PROJECT		
Proposed modification to OSD tank and stormwater layout to reduce on site rock excavation.		
D	MODS. TO STORMWATER SEC. 4.55 APPL.	MAR. 2025
C	RAINWATER TANK REPOSITIONED TO SIDE SETBACK	MAR. 2022
B	ISSUED FOR CC APPLICATION	MAR. 2022
A	ISSUED FOR DA APPLICATION	OCT. 2020

ADDRESS		
4 Southern Cress Way Allambie Heights NSW		
CLIENT Mr. Chris Jaczac		
DRAWN AJ	SCALE 1:200	DATE 2025.03.23
DRAWING No: PR020.03, Page 1		ISSUE D

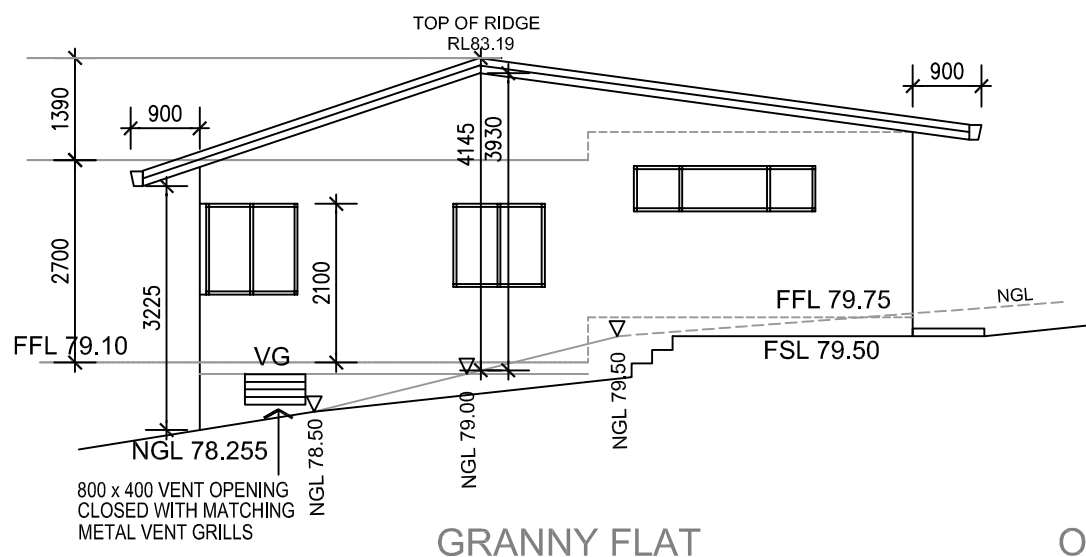
NO CHANGES ARE PROPOSED TO ANY OF THE DEVELOPMENT CALCULATIONS OR LAYOUTS APART PROPOSAL ON P8a & P9.

Construct a concrete apron upturn on both sides of the suspended concrete driveway as shown on the side elevations.

GRANNY FLAT AND STUDIO SUB-FLOOR LAYOUT

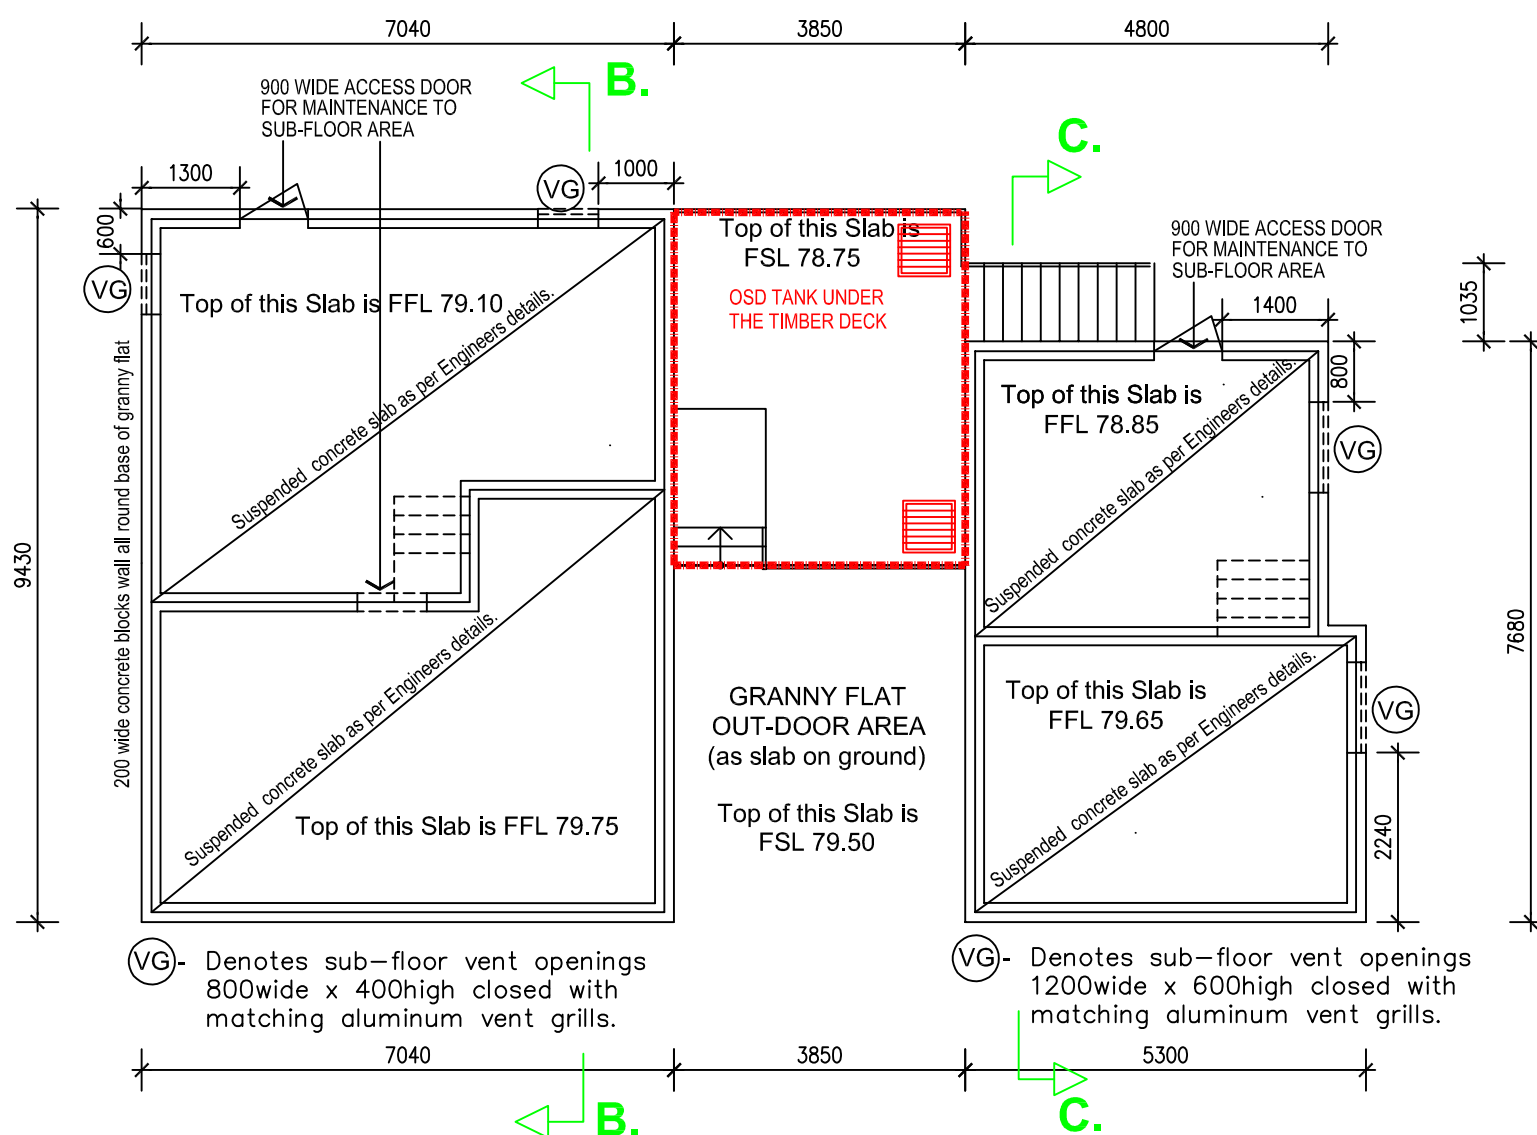
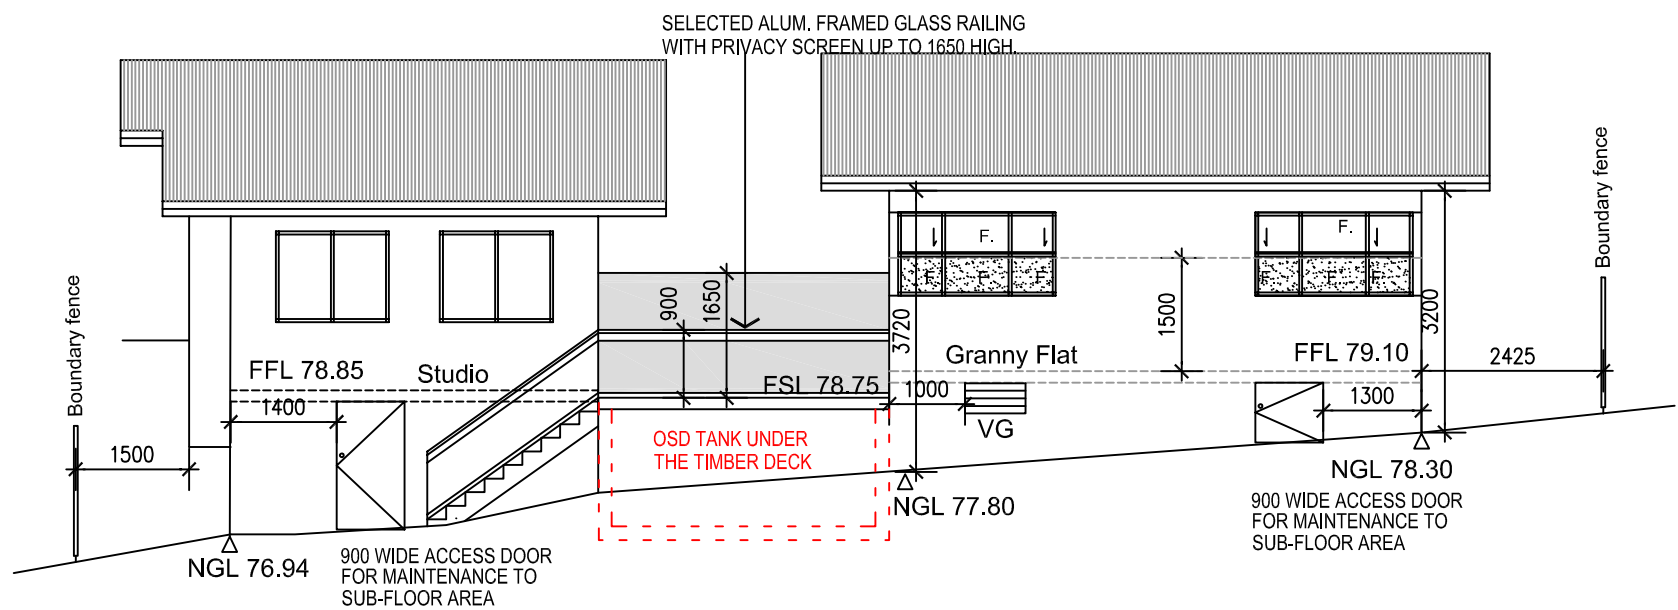
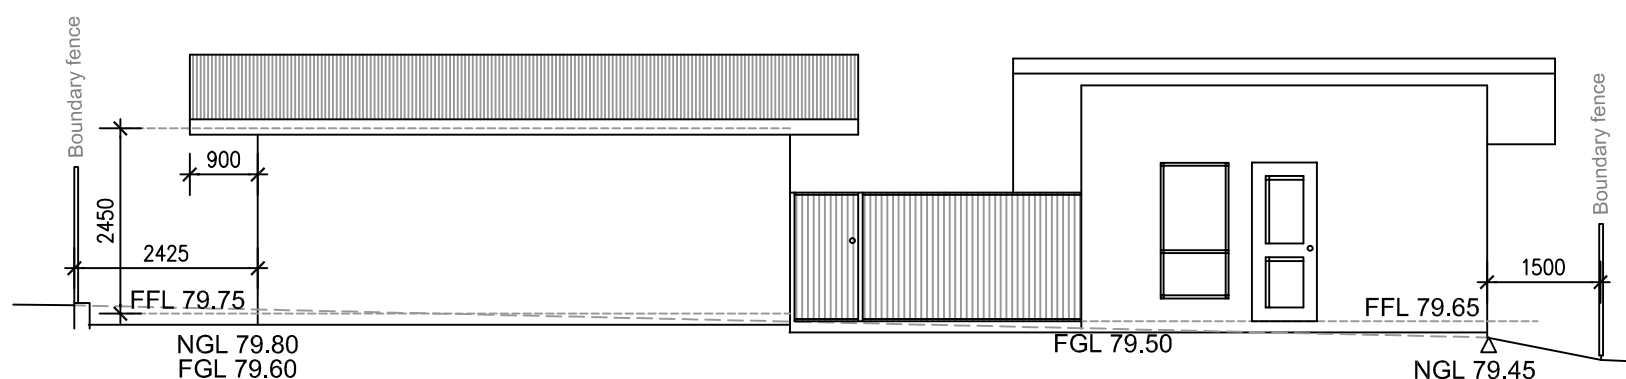
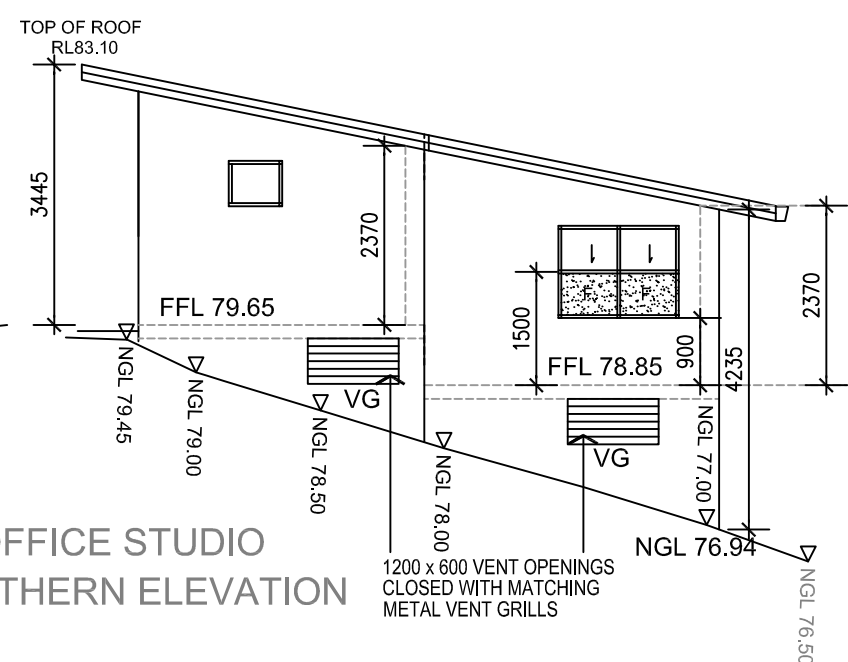
Proposed modification to OSD tank and stormwater layout to reduce on site rock excavation.

D	MODS. TO STORMWATER SEC. 4.55 APPL.	MAR. 2025
C	ISSUED FOR SEC. 4.55 APPLICATION	DEC. 2024
B	ISSUED FOR CC APPLICATION	MAR. 2022
A	ISSUED FOR DA LODGMENT	OCT. 2020

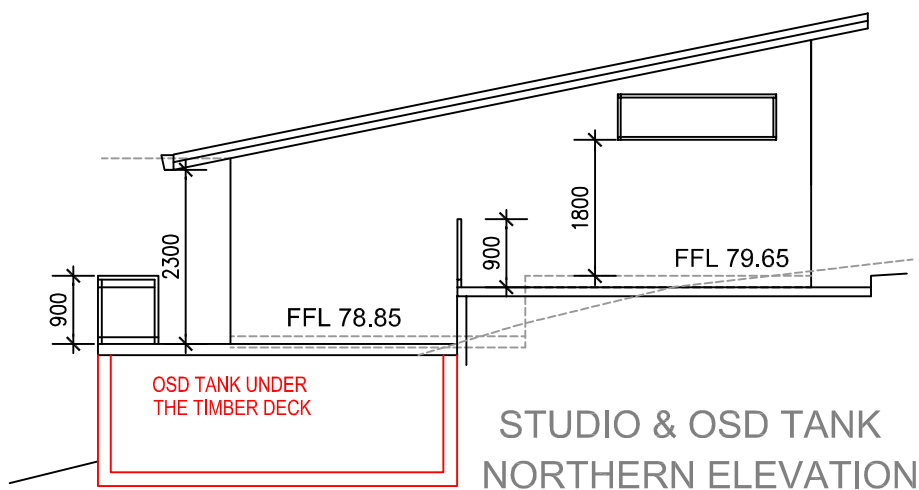
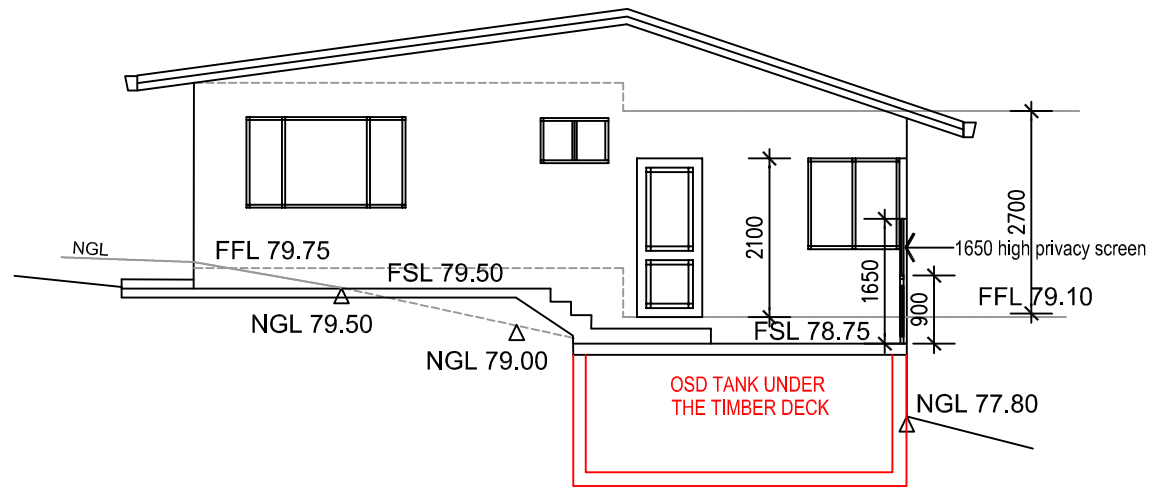
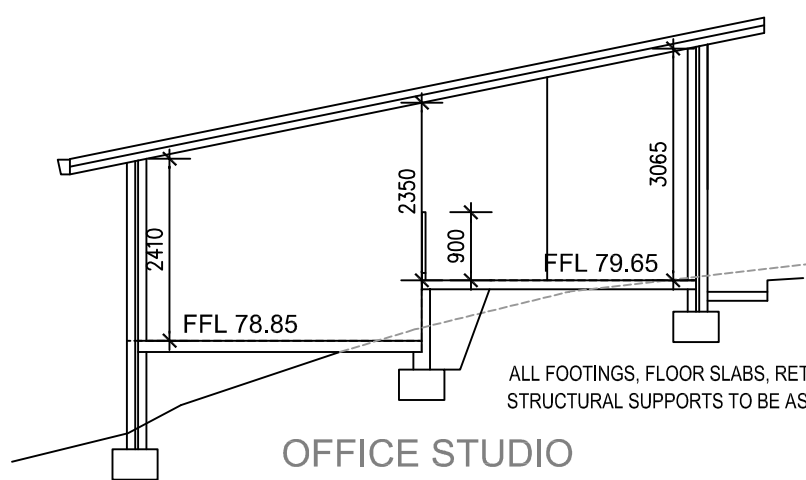
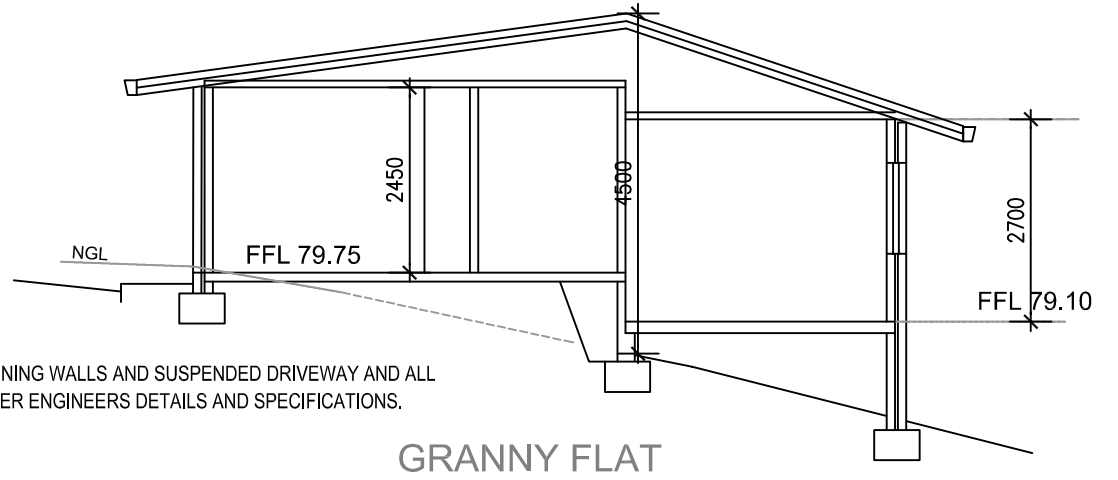
PROJECT		
Proposed modification to OSD tank and stormwater layout to reduce on site rock excavation.		
D	MODS. TO STORMWATER SEC. 4.55 APPL.	MAR. 2025
C	MODS. TO SUB FLOOR SEC. 4.55 APPL.	DEC. 2024
B	ISSUED FOR CC APPLICATION	MAR. 2022
A	ISSUED FOR DA LODGMENT	OCT. 2020
